Mr. Andrew McAllister
Commissioner
California Energy Commission
Dockets Office, MS-4
Re: Docket # 14-BSTD-01
1516 Ninth Street
Sacramento, CA 95814-5512

**Notice of Staff Workshop on Draft
Language for the Residential and
Nonresidential Building Energy
Efficiency Standards and Associated
Documents**

Comments for Proposed Language for 2016 Title 24 Part 06 & 2016 Joint Appendices

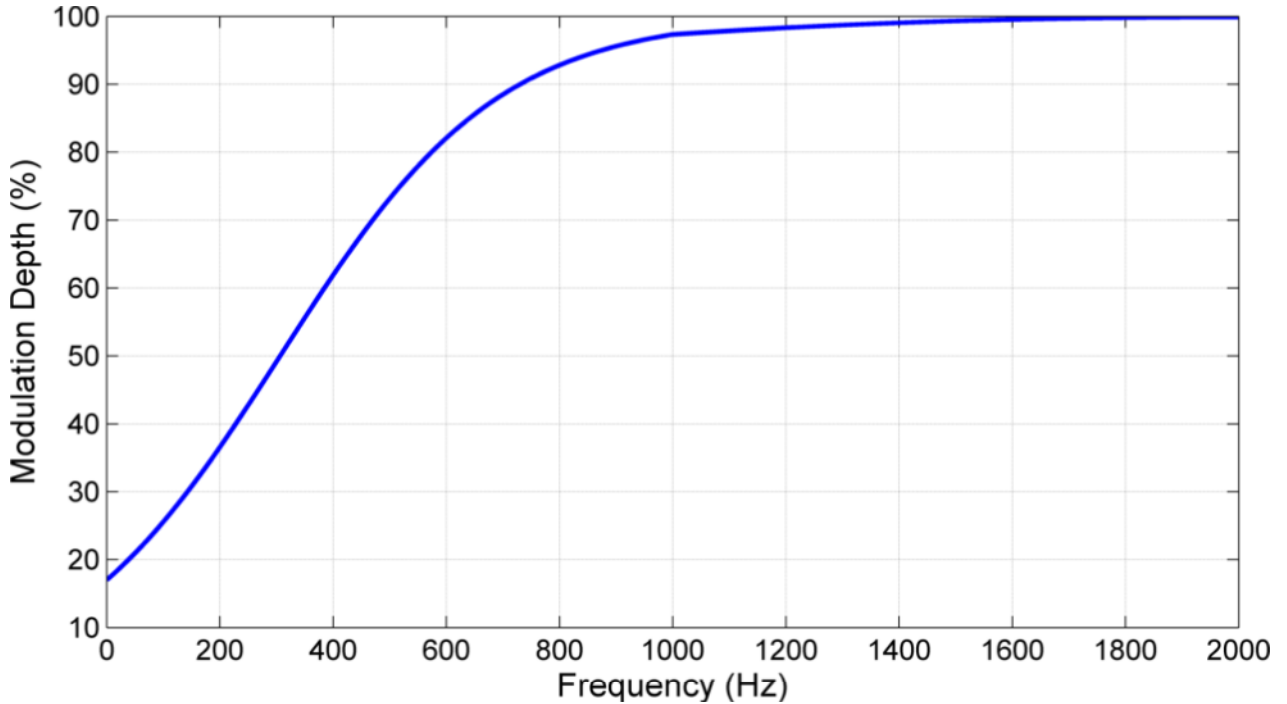
The Title 20 specification on flicker is overly restrictive for some frequencies and too lax for others. It states:

“Dimmer controls that can directly control lamps shall provide electrical outputs to lamps for reduced flicker operation through the dimming range so that the light output has an amplitude modulation of less than 30 percent for frequencies less than 200 Hz without causing premature lamp failure.”

This specification makes no allowance for the dependence of human flicker sensitivity either on frequency or on wave shape. For sine wave modulation, the visibility threshold for stroboscopic effects¹, expressed in terms of modulation depth, is shown in the figure below. At a particular frequency, modulation depths above the curve can be detected by most people. Below the curve, they are not detected by most people. The threshold changes for different wave shapes, in a way that depends on the Fourier components of the light output waveform. A full Fourier approach would take account of both frequency and wave shape effects². Sensitivity to flicker also depends on the application. Flicker in outdoor street lighting or in stairwells is more tolerated than in indoor offices, for instance. Therefore, a curve of *acceptability* may be above the *visibility threshold* curve. Different curves may be needed for different applications.

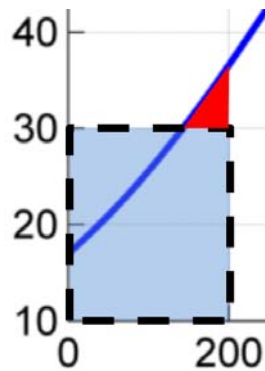
Zooming in on the region from 0 to 200 Hz in the figure above, the shaded rectangular region with dashed outline represents the conditions allowed by the Title 20 specification. The red triangle is forbidden by the Title 20 specification, but flicker in this region is not visible to most observers. Title 20, as a MINIMUM specification, should not exclude acceptable regions where flicker is not even be detected.

The Title 20 specification does a poor job of defining acceptable flicker levels, and the test procedure in Title 24 does a poor job of determining flicker acceptability. Specifications on flicker and test procedures should wait until the experts (in IEEE and in IEC) conclude their work on this topic and produce a solid standard. Energy Star is also collecting data on flicker and should complete their work and make recommendations before California produces its own specification.

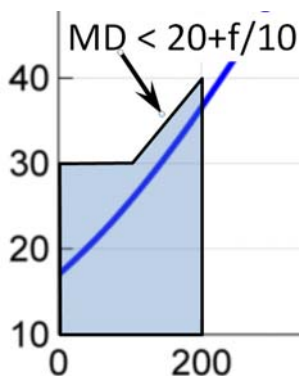
If CEC is unwilling to remove the flicker specification and wait for agreement in standards organizations, then CEC should at the very least modify the present specification to allow use of

the acceptable flicker region denoted by the red triangle in the figure above. We suggest modifying the specification to allow flicker in the region shown in the figure below. The specification would then be:

“Dimmer controls that can directly control lamps shall provide electrical outputs to lamps for reduced flicker operation through the dimming range so that the light output has an amplitude modulation of:

- less than 30 percent for frequencies less than 100 Hz,
 - below the line: Modulation Depth = $20\% + \text{Frequency}/10$, for frequencies from 100 to 200 Hz,
- without causing premature lamp failure.”
